## Product Change Notification

### H-Relays

#### H-Relay Series – Diameter increase of the coil wire outlet

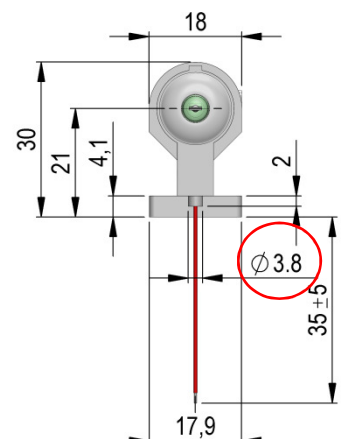
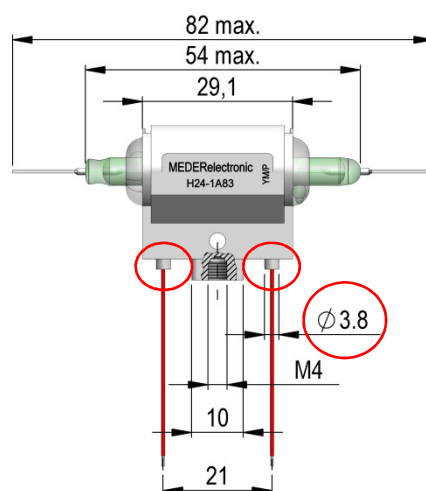
Due to continuous improvements, the diameter of the coil wire outlet on the bottom of the relay is to be increased from 2.8 mm to 3.8 mm (+/- 0.2).

This modification will guarantee a better isolation and robustness, but will not affect any present electrical or mechanical properties of the relay. All relay descriptions and names will stay the same.
